LOCATION	CAR PARK L3
SWITCHBOARD	TEE OFF BOX FOR DB 3-1-10
COMPONENT	Fuse White Phase
OBSERVATION	Line Side Connection

Date: 17/01/2006

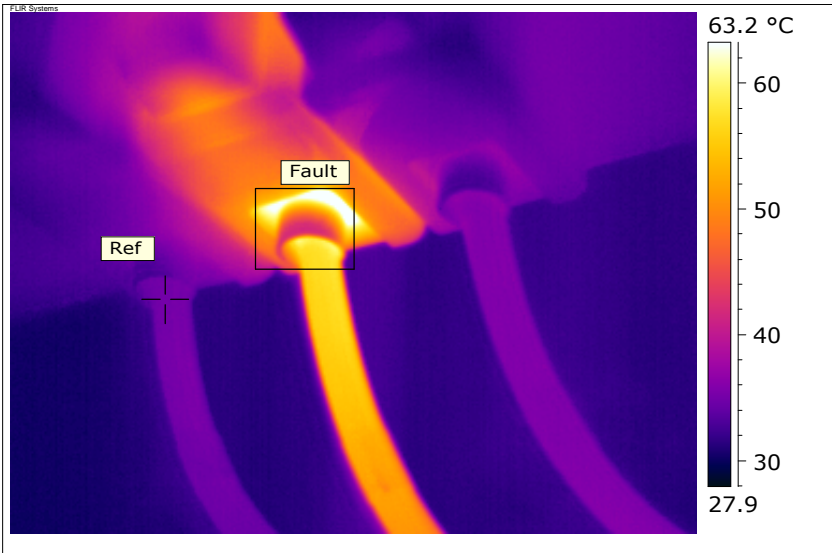
Label	Value
Ref	35.1 °C
Fault: Max	69.8 °C
Temp Diff.	34.8

Red Phase	68 amps
White Phase	54 amps
Blue Phase	42 amps

Clean, check and tighten connection, the fuse base and wedge may need to be replaced.
